nd Management Parameters for 10 Mb/s Operation and Associated Power Delivery over a Single Balance

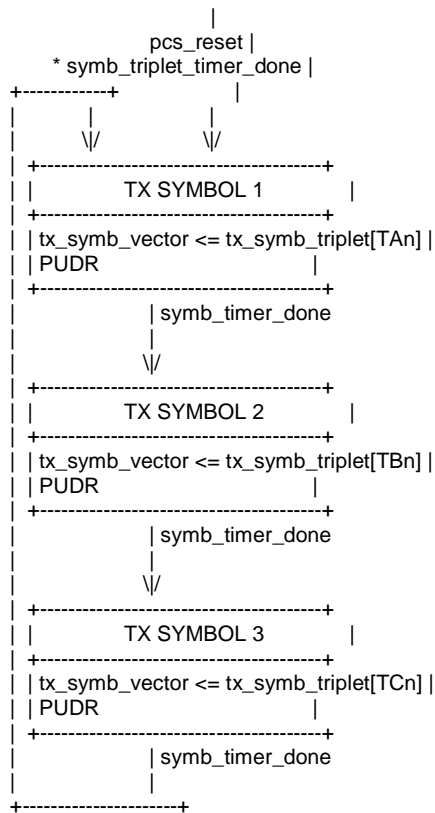
A triplet of ternary symbols generated by the PCS Transmit state diagram. The element TAn is the first ternary symbol transmitted; TCn is the last ternary symbol transmitted.

Value: A triplet of ternary transmit symbols. Each of the ternary symbols may take on one of the values {-1, 0, +1}.

[4] Add a new subclause 146.3.3.2.2 titled 'Timers'. Move the symb_timer definition from subclause 146.3.3.1.3 Timers to this new subclause.

[6] Insert a new Figure 145-6 shown below (view using a non-proportional font such as courier), renumbering the following figures as required.

[7] Add text to subclause 146.3.3 'PCS Transmit' that reads 'The PCS Transmit function shall conform to the PCS Transmit state diagram in in Figure 146-5 and the PCS Transmit multiplexor state diagram in 146-6, and their associated state variables, functions, timers, and messages.'
